Sub: Implementation of the Access Audit report of New Delhi Railway Station.

NEW DELHI RAILWAY STATION

Second Access Audit Report (Review)

9th April 2005

PARKING SIGNAGE

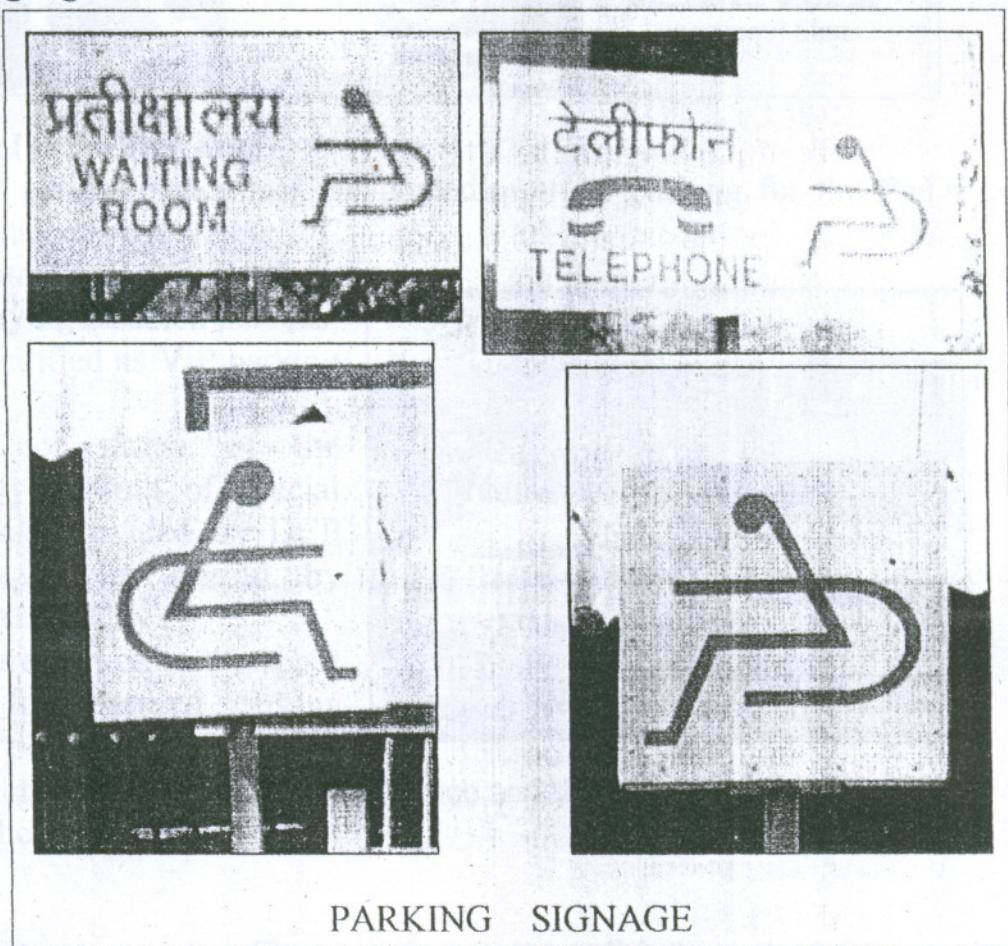
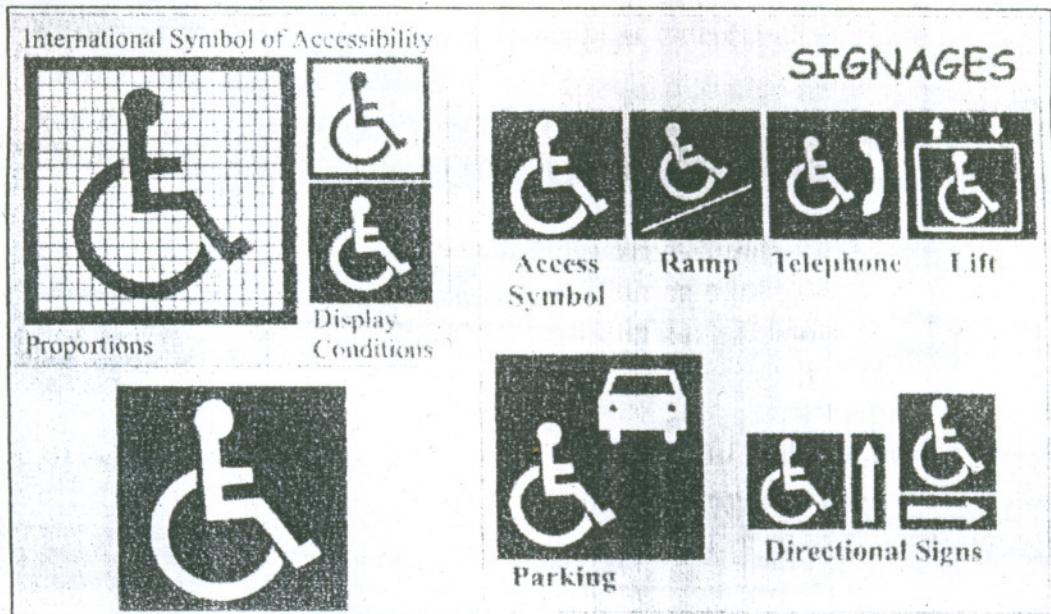
All signages need modifications.

Access symbol which is internationally used and universally accepted should be provided as per the standards mentioned below.

Existing signage

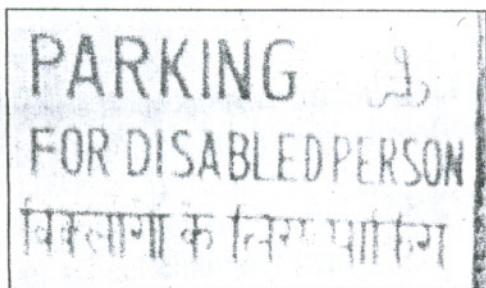
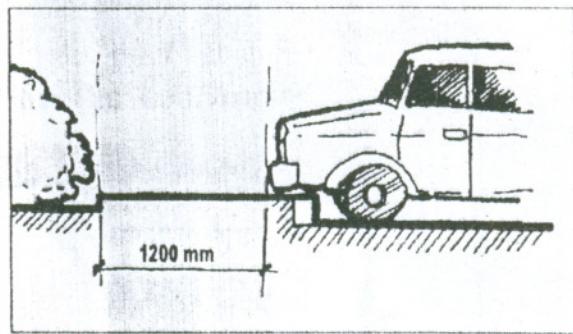
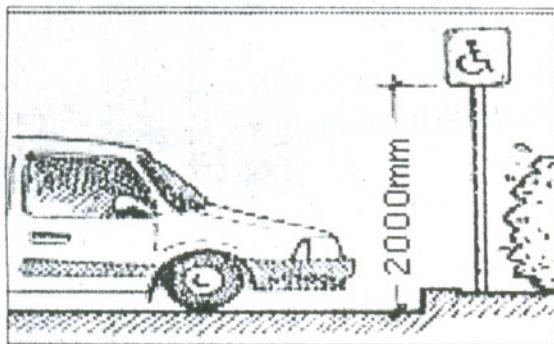
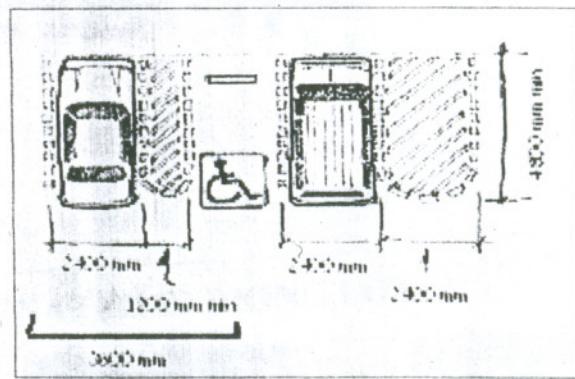
1. Parking contractors do not allow vehicles carrying disabled persons, as this is identified as VIP parking lot.
2. They are not aware of the usage/priority parking of special parking labels provided by DCP traffic, to vehicles owned by persons with disability.
3. Other cars are parked in the space designated for reserved parking for disabled persons.
4. Signage is not clearly visible from a distance and there is no access symbol painted on the ground.

All parking contractors and traffic personnel to be well informed of the usage of reserved parking space and priority parking stickers.

Designated parking lot to be:

- The minimum width of an accessible parking is 3600mm. (Overall minimum dimension being 3600mm -4800mm)
- Reserved parking spaces for vehicles carrying PwDs should have the international signage painted on the ground and also on a signpost\ board put near it.
- There needs to be directional signs guiding people to the accessible parking.

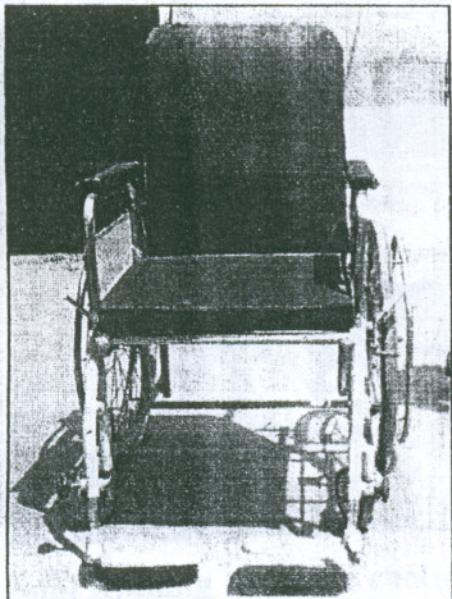
- It was observed that after dropping the passengers, coolies bring wheel chair back from the stair cases causing damage, wear and tear.
- All wheel chairs should be given general maintenance from time to time for example foot rest should be on the same level; etc.
- Porters/coolies to be trained about the mobility needs of wheel chair users, transfer techniques etc.

Drinking water facility

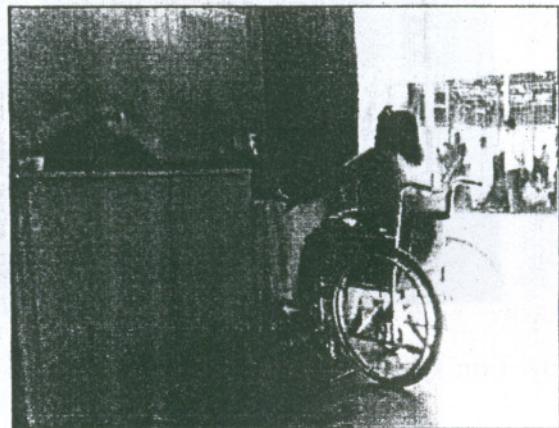
There is a separate lowered drinking water tap for disabled persons. However due to lack of knee and leg space, it becomes difficult for wheel chair users to reach the tap.

- A water fountain with leg and knee space may be provided as per the figure.

Existing toilet and washroom: needs modification

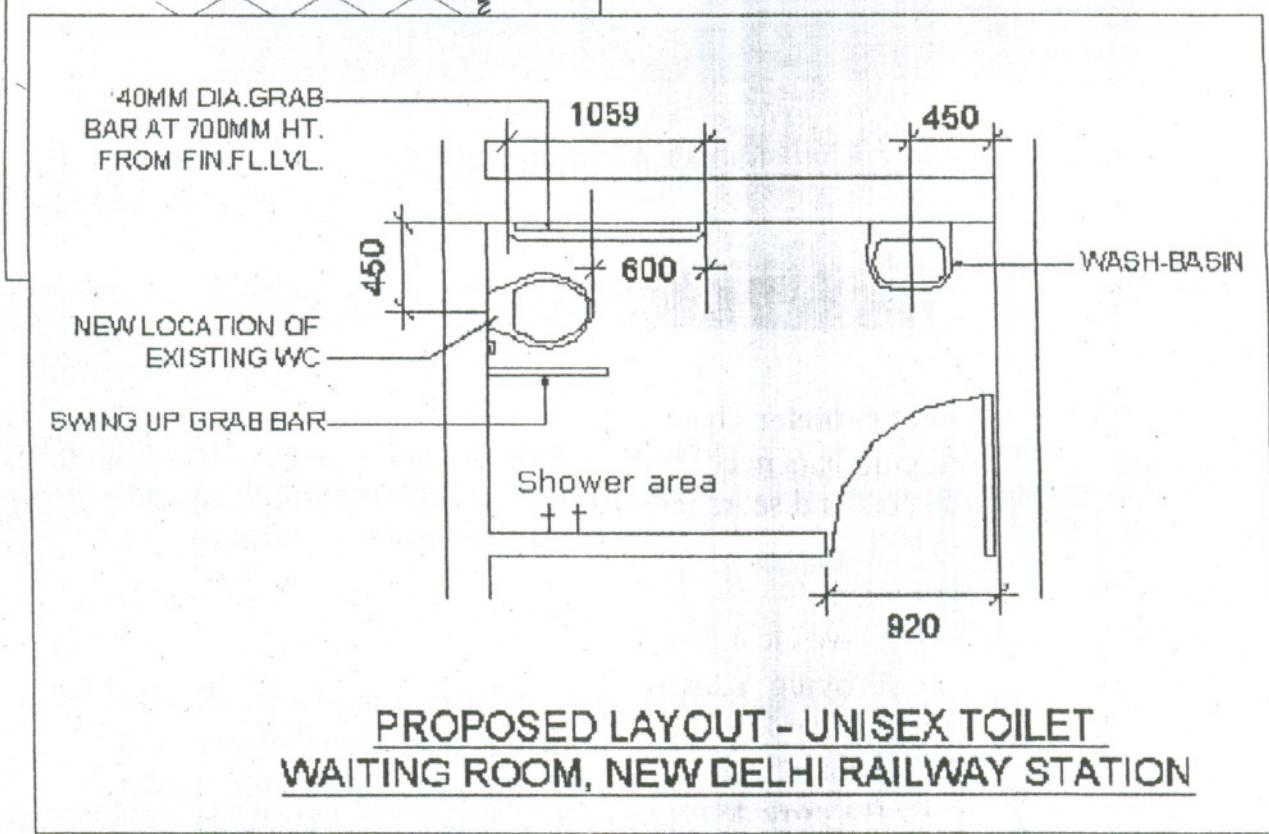
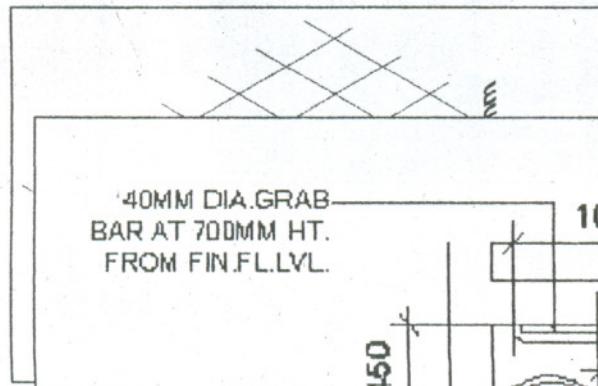
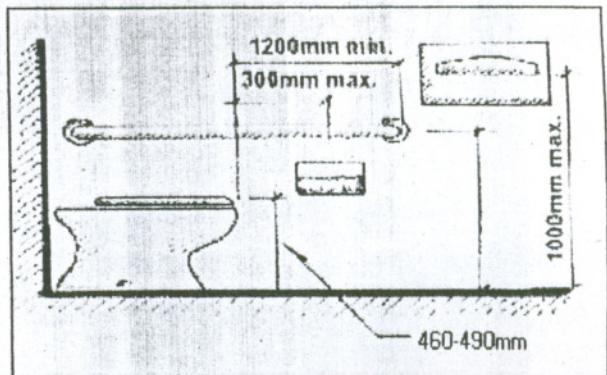
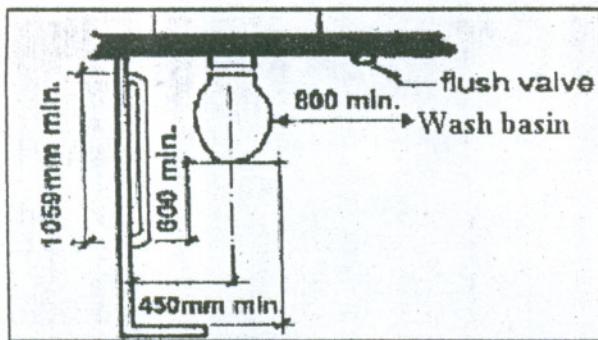
Toilet cubicle: There is enough space inside the toilet. However WC, washbasin and grab bars needs to be relocated, to provide front and parallel wheelchair transfers and segregate between the wet and dry area.

- Have clear space of not less than 900mm wide next to the water closet.
- Provide a door of clear opening of at least 900mm with the door swing outwards or be folding or be sliding type.
- Should have slip resistant flooring.
- Be provided with a horizontal pull bar at least 600mm long on the inside and 140mm long on the outside, at a height of 1100mm.

- Be located between 460mm to 480mm from the centerline of the WC to the adjacent wall and have a clear dimension of 750mm from the edge of the WC to the rear wall to facilitate side transfer.
- The top of the WC to be 450mm-490mm from the floor.

Over head/foot over bridges

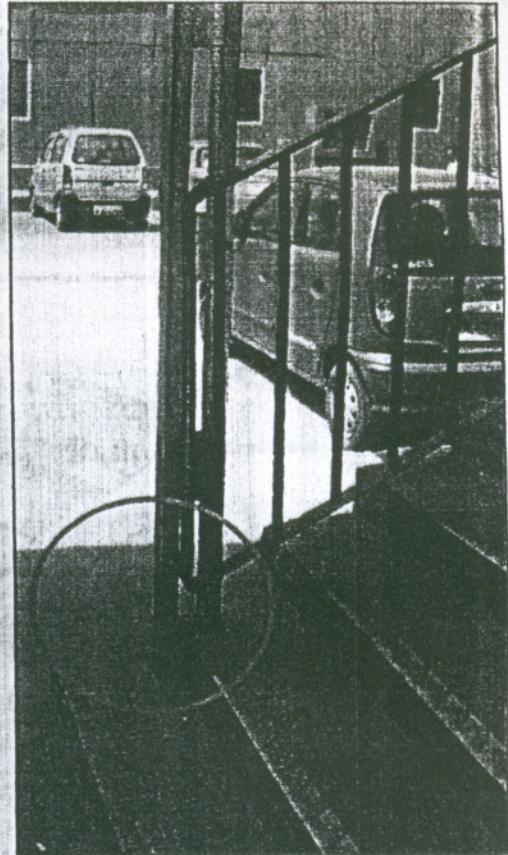
Handrails on the foot over bridges start after one step, thereby making it difficult for persons with reduced mobility and PwDs to move up/down the steps.

- Should be circular in section with a diameter of 40-45mm;
- At least 45mm clear of the surface to which they are attached;
- At the height of 850mm-900mm from the floor,
- Extend by at least 300mm beyond the head and foot of the flight in the line of travel and grouted in the ground.

Protruding objects

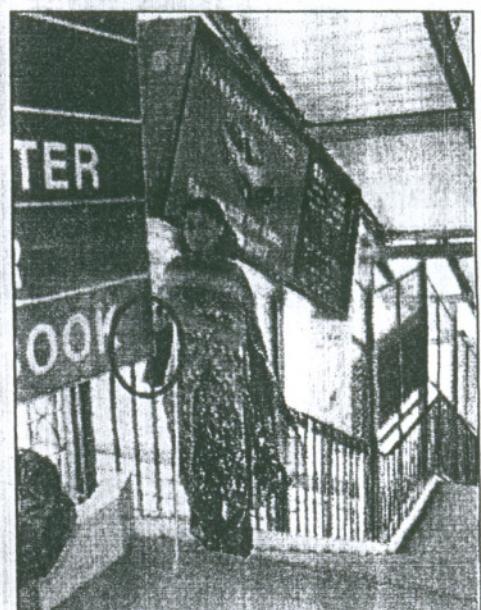
There are hoardings and other signages on the poles etc., obstruct movement of persons with vision impairment and can cause injuries.

- All protruding objects to be above 2100mm from the floor level.

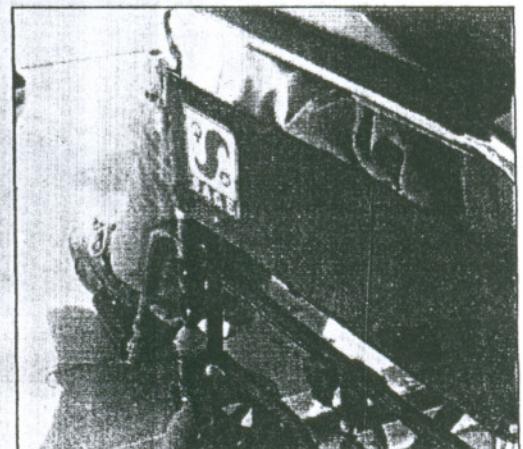
Platform crossing- route identified for persons with loco motor disabilities, over the tracks, is used for carrying parcels & luggage on wheel carts.

In absence of lifts for all foot over bridges, this pathway is identified and used by persons with loco motor disabilities.

Ramp leading to crossing is very steep.

- Gentle gradient of 1:12 is recommended.

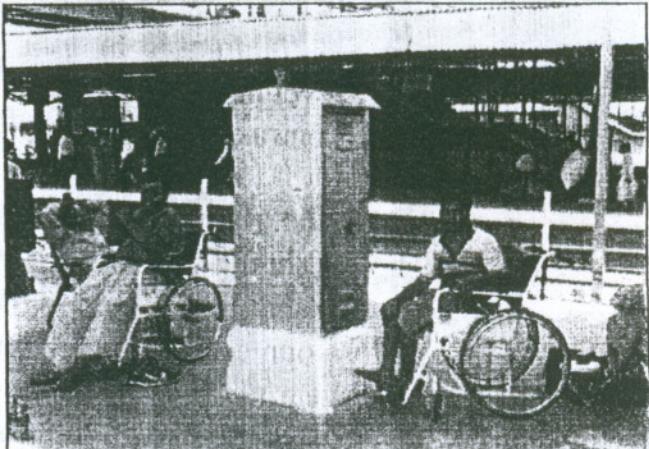
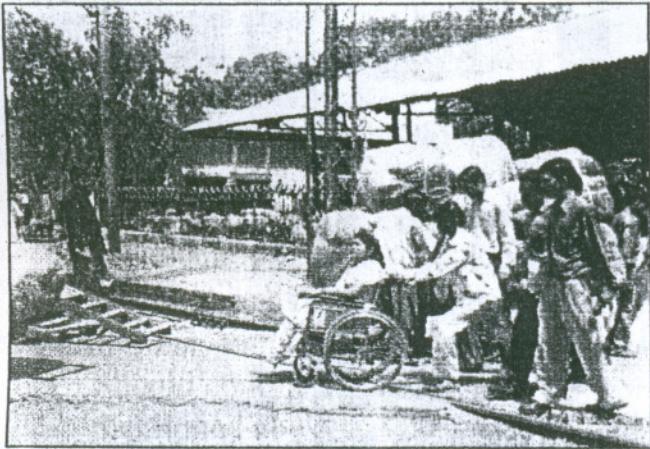
Surface of the pathway is uneven and it is strenuous and tiring for PwDs and people carrying heavy luggage.

- Surface needs to be leveled out and maintained from time to time.
- Cement/concrete/any other material may be used to provide firm, uneven and slip resistant surface.
- It is suggested to provide an overhead shed to save everyone from the adverse climate conditions.

Ticket Counter

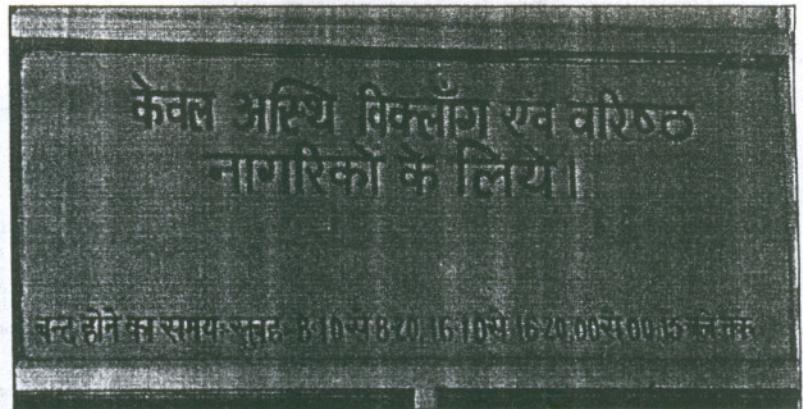
Signage is placed too high and text is not clearly visible.

Access symbol is not provided.

- Signs should be mounted at 2000mm from floor level in bold & contrasting colors, with access symbol as per standards.
